# C37.60

Technical Proposals Reviews  
Lightning impulse withstand voltage – conditioning procedure

# **C37.60 - Reclosers DLMT Ad hoc: updating fig. 3 with the missing source**

# **C37.60 - Reclosers DLMT: Introduce a new testing condition which allow to omit T5 and T10 low current duties**

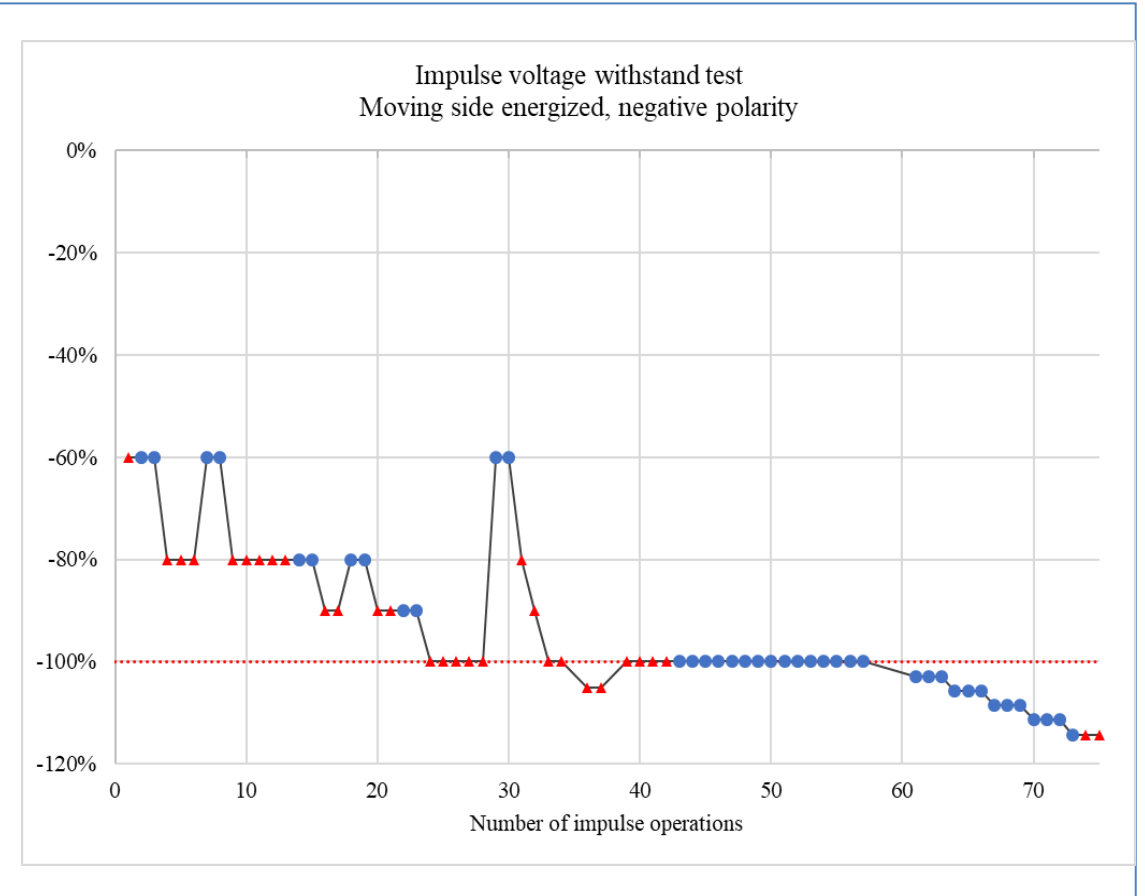
- The number of preliminary impulse tests (25) seems arbitrarily chosen.
- It has been demonstrated that certain vacuum interrupter units require more than 25 conditioning impulses to perform at their rated impulse level.
- Additionally, conditioning at higher-than-rated impulse levels (105% for example) has been shown to be beneficial in certain cases.

Figure 3 – Three-phase short-circuit representation

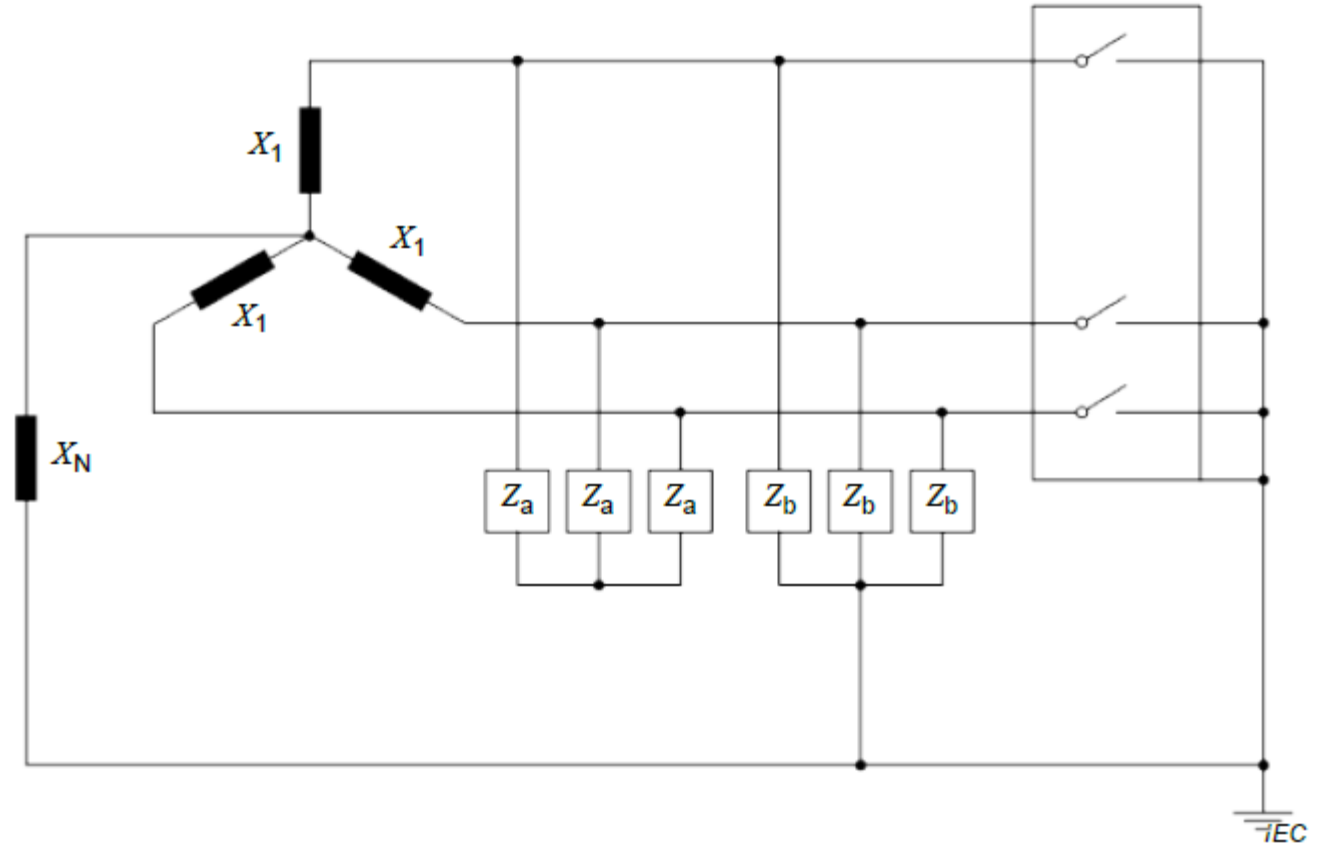
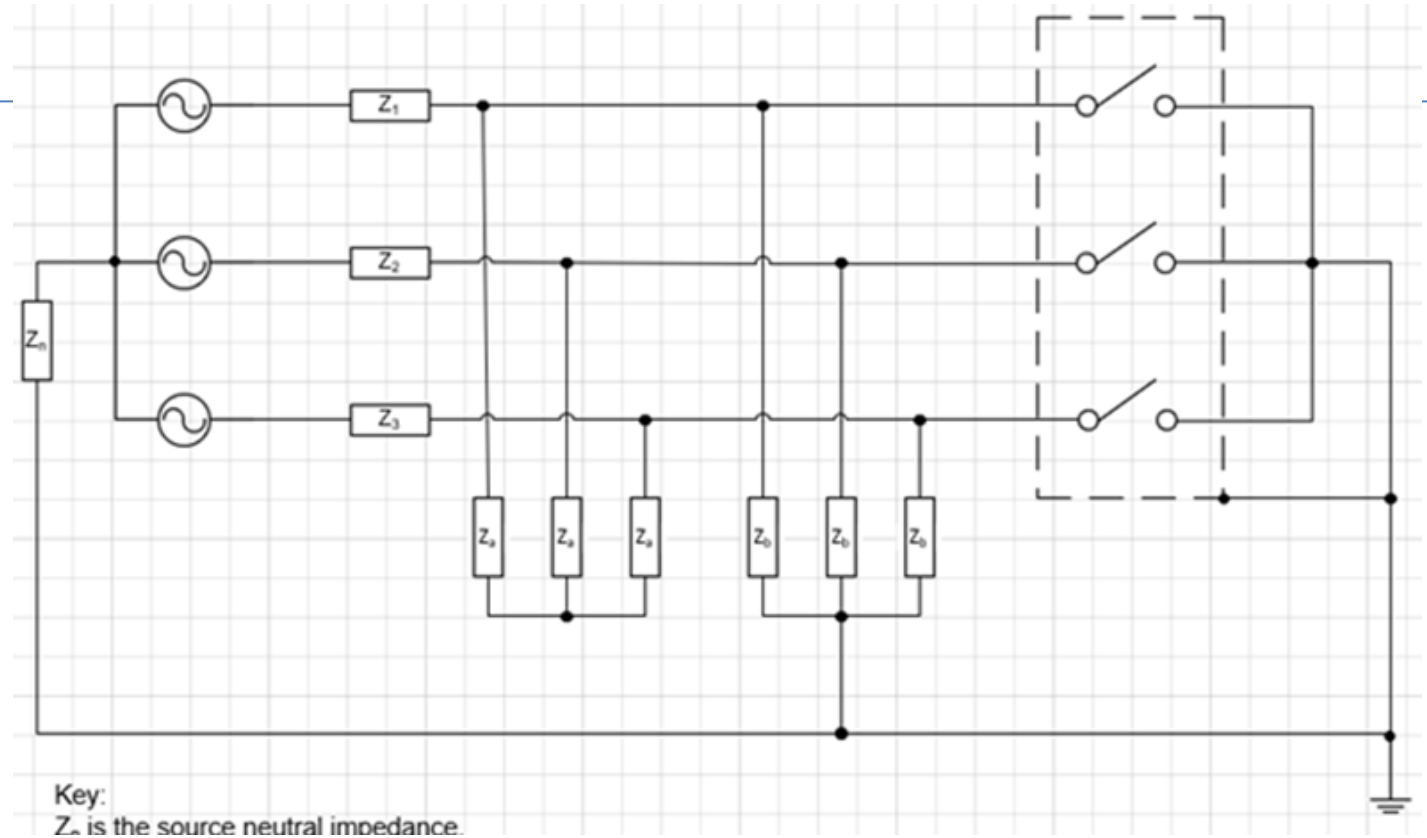
- An expert pointed out that a reference was wrong.

- Harm will revise the drawing accordingly. Following the update, the new figure will be inserted into the draft document.

## 7.104.4 Low current test-duty

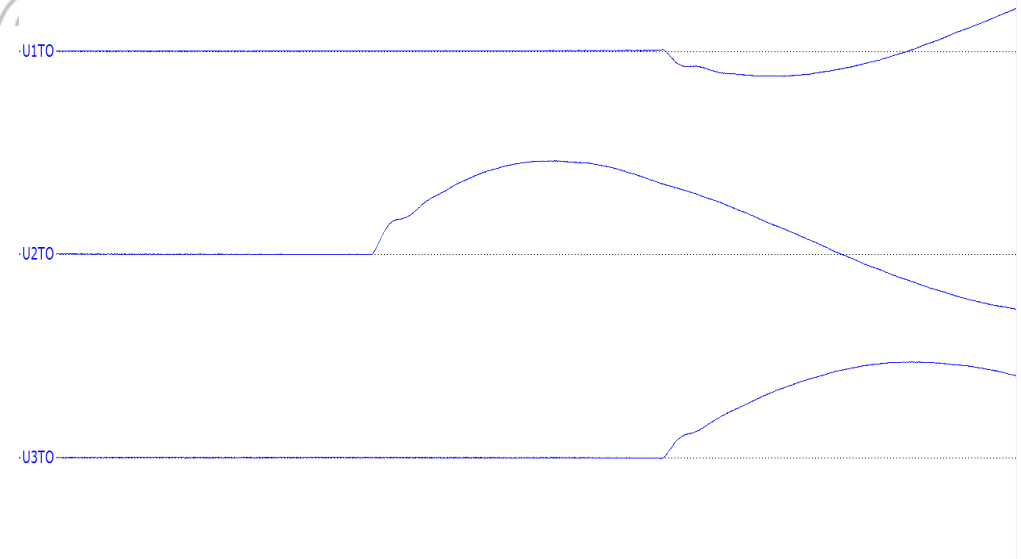
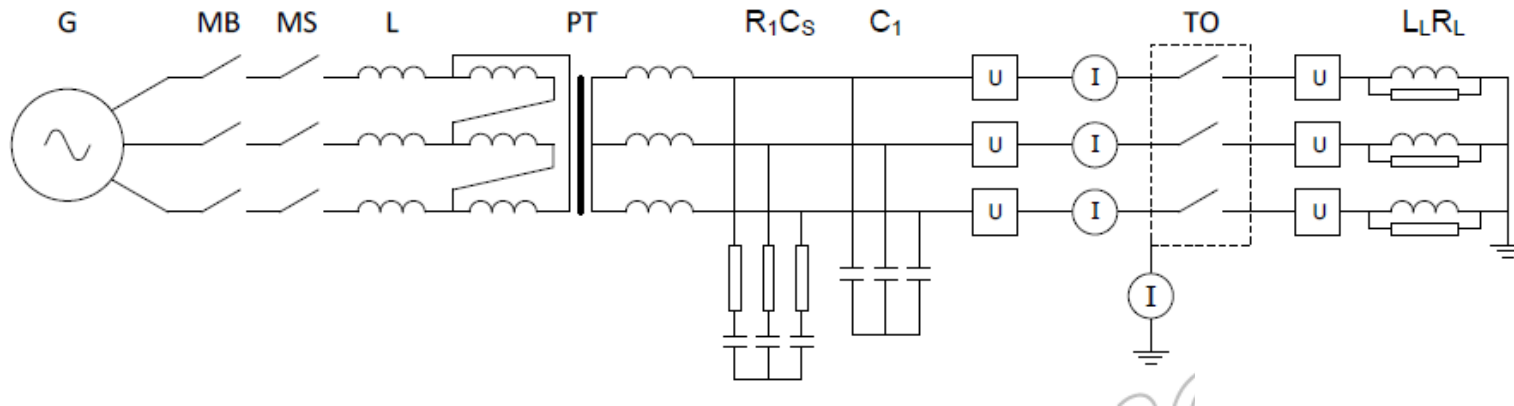
- T5 and T10 circuits
  - These circuits are entirely inductive and not representing load switching.
- Critical current tests are known and used in circuit breaker standards
  - It shall be assumed that there is a critical current if the minimum arcing times in the test-duties of either T20 or T50 is one halfcycle or longer than the minimum arcing times in the adjacent test duties. For three-phase tests the arcing times of all three phases shall be taken into account.
- No need for additional prove for load switching, this is covered by the basic short-circuit test duties(T100, T50 and T20).
  - As handled by circuit breakers standards.
- Go back to the previous standard (critical current) as specified 2007 edition.

- Go back to the previous standard (critical current) as specified 2007 edition.
  - T5 and T10 only applicable if there is critical current.
